Stantec Consulting Services Inc. 778 Main Street Suite 8, South Portland ME 04106-5447

Subject: 421 Warren Avenue Site Plan Revision Email Comments Received by Jean Fraser Dated February 16, 2016 Letter of Response #1

R:\STANTEC\195350330 Safelight Warren Ave\civil\cadd\permit\dwg\SP-M104-SITE EXP.dwg fillie_p 2/19/2016 4:25 PM

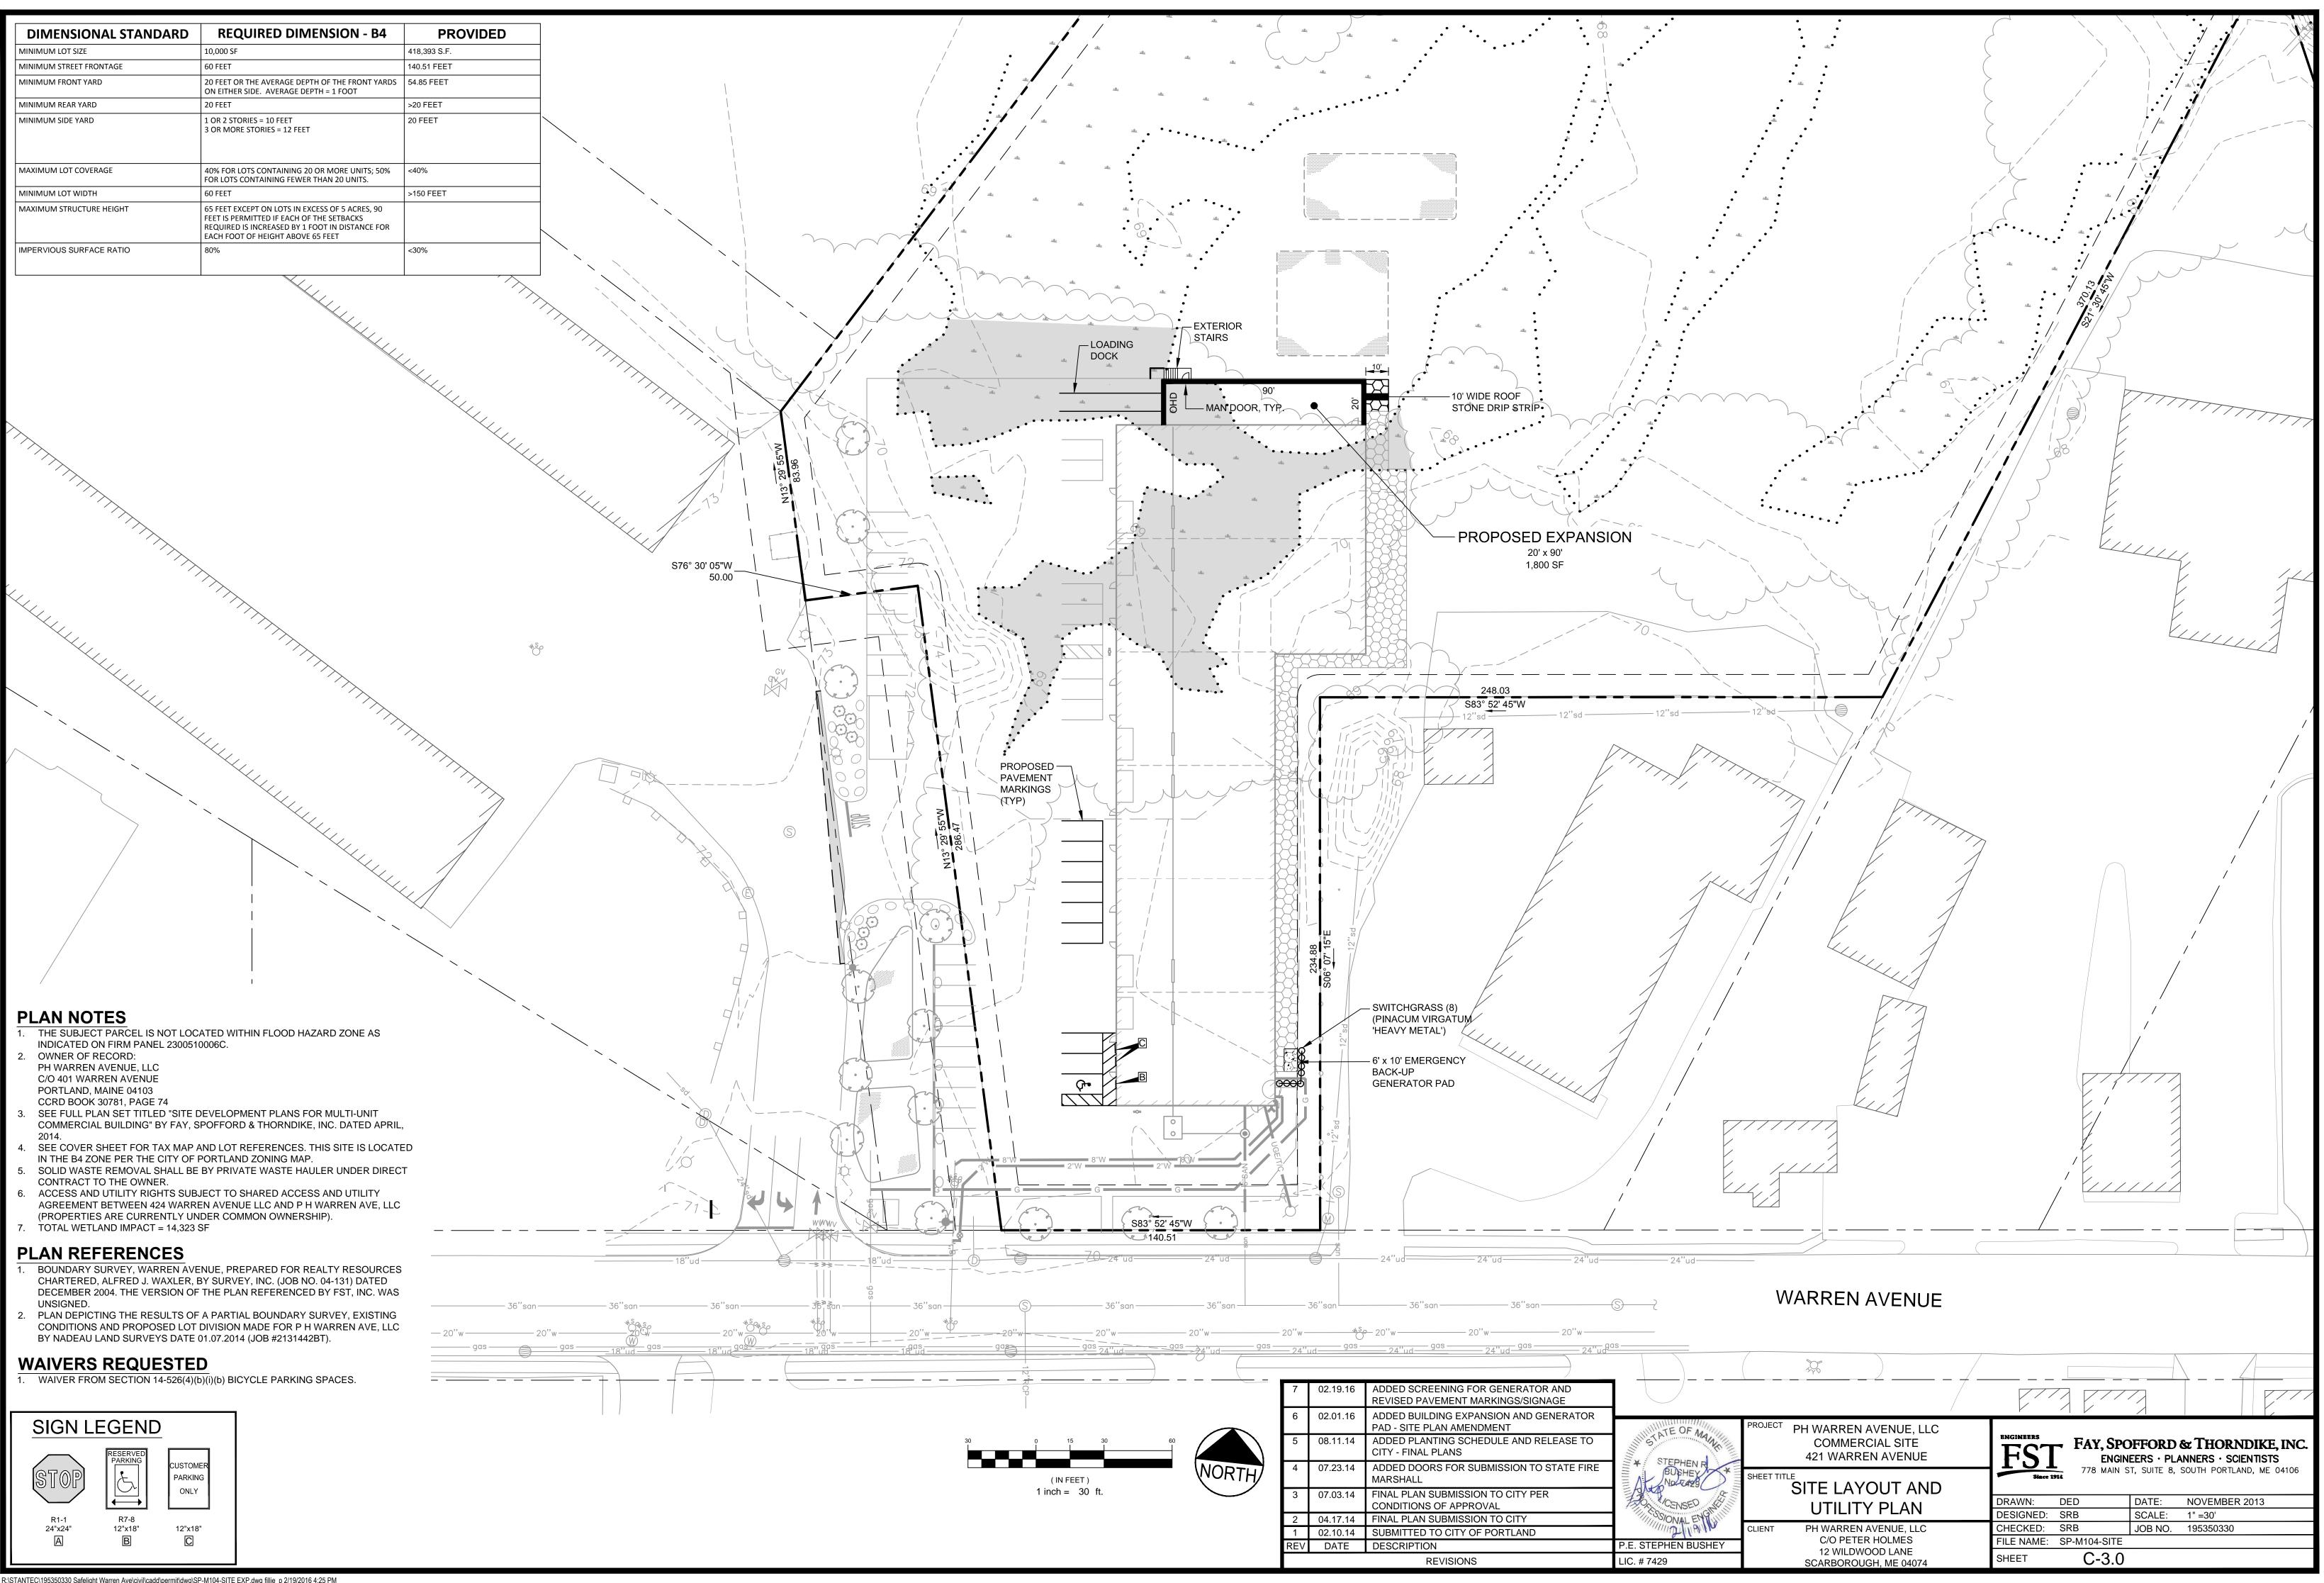
Parking: Please amend the site plan (attached) so that there is no parking shown in front of the garage doors and main entrance for the two bay in-shop area for glass repairs with a customer waiting area. The area in front of the entrance door should be striped and ideally there should be ADA access and ADA parking for customers waiting to go into the bay. Maybe a sign saying "customer parking" so those spaces get reserved?

Lighting: We approved the lighting plan (attached) based on it being a commercial use with no or little public use. Now that the public are on the site at the end near Warren, I think the lighting needs to evaluated in terms of safety for customers. If customers need to park in the parking spaces away from the building there is no light there. I'd like it documented that the public safety and public security (CPTED) issues (site plan standards) here has been addressed.

The Site Plan has been modified to realign the parking area striping to avoid conflict with overhead and entry doors. We have also added an ADA space at the front of the office area. The site will contain at least 35 parking spaces which is considered more than enough for the intended use and expected parking demand.

The Lighting Plan has been updated to provide two additional building mounted light fixtures. These have been added to the front left corner of the building and in the area of the new loading dock. We believe there is adequate lighting along the front of the building to assure safety and security. There are existing pole mounted lights along the main project entrance off Warren Avenue; therefore, provide some lighting coverage along the entrance. On this basis, the owner is seeking to not install any additional pole mounted lights on the outside of the new parking area.
